Re: Kirtland – Michigan Forest Products Institute Building and Student Services Addition

Addendum No. 2

Project: Kirtland Community College- Phase 2
Michigan Forest Products Institute Building and
Student Services Addition
4800 W. Four Mile Road
Grayling, MI 49738

Re: Addendum #2

Partial Sheet A2.3:

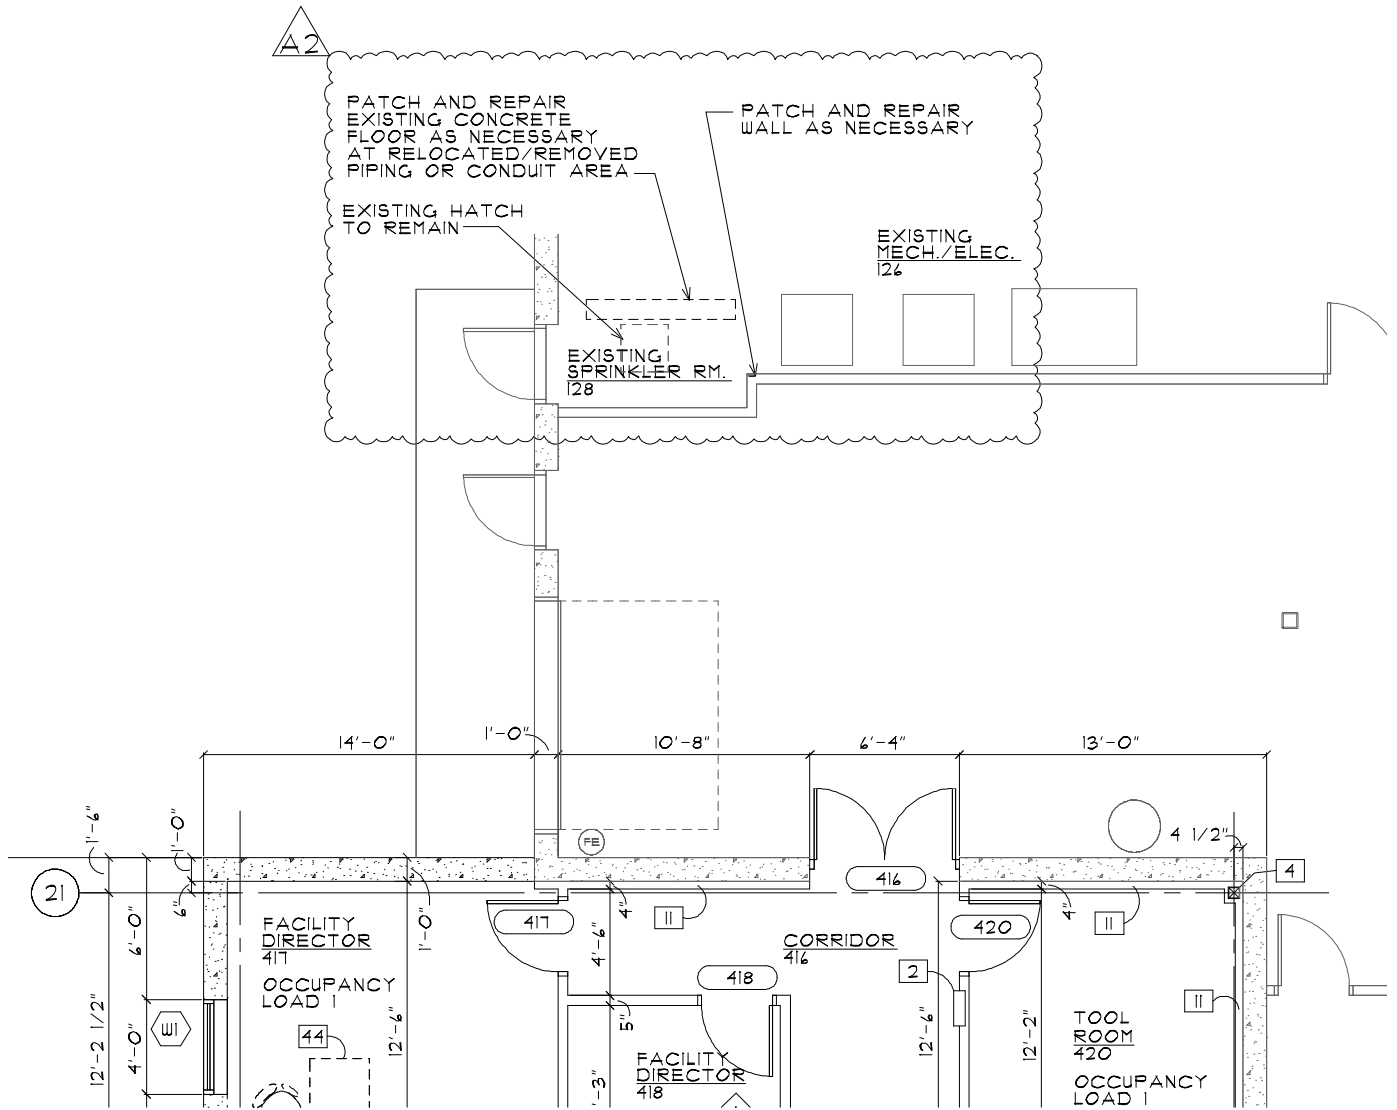
4. Old Fire Sprinkler Room 128- Demo plan shows removing the sprinkler riser and west wall of room, making the existing mechanical room larger. Bids to include patching and repairing walls as necessary after removing the west wall. Also include patching and repairing existing concrete floor as necessary if any pipes or conduits are moved/removed. Architectural Sheet A2.3 has been updated. See partial sheet A2.3 below.
